- DESIGN CHANGES
1. Modular end links re-positioned slightly off existing buildings, with the party wall straightened and porch projections aligned with this wall, to ensure modular construction can be achieved off site.

Project	COUNTY FLATS, SANDFIELDS
Project number	N297
Client	HALE CONSTRUCTION LTD
Title	BLOCK 05/06 ELEVATIONS 2/2
Drawing number	A016
Scale	1 : 100 at A1
Revision	J
Status	INFORMATION
Drawn	PC
Date	30.11.21

01 E08 - Block 5 Open Public Space Elevation
1 : 100

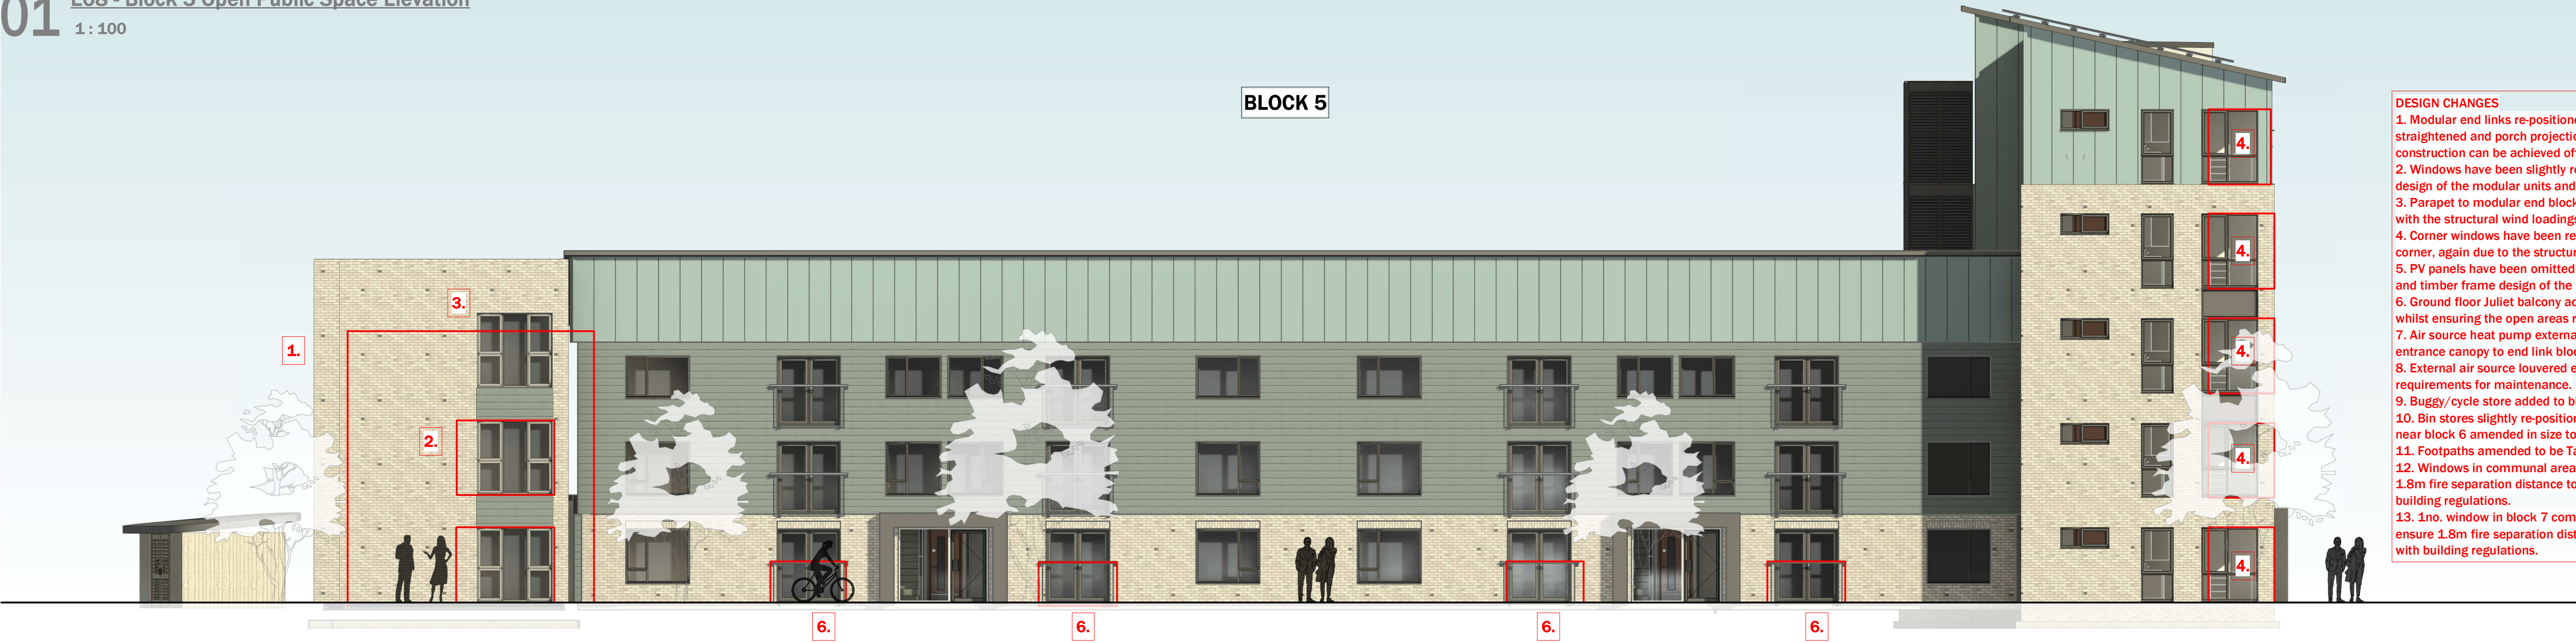
2. Windows have been slightly re-positioned to the new build to suit the structural design of the modular units and the constraints of the timber frame.

3. Parapet to modular end blocks have been lowered by approx 900mm to comply with the structural wind loadings and timber frame design.
 4. Corner windows have been removed and replaced with 2no. Windows on either corner, again due to the structural and timber frame design of the blocks.

5. PV panels have been omitted from the end modular units to suit the structural and timber frame design of the blocks.
 6. Ground floor Juliet balcony added to existing flats to provide better security whilst ensuring the open areas remain as communal spaces.

7. Air source heat pump external louvre enclosure amended to be single storey over entrance canopy to end link blocks.
 8. External air source louvered enclosure handed to provide internal riser/access requirements for maintenance.

11. Footpaths amended to be Tarmac.
 12. Windows in communal area to the linked blocks made narrower to ensure 1.8m fire separation distance to existing windows is achieved to comply with building regulations.
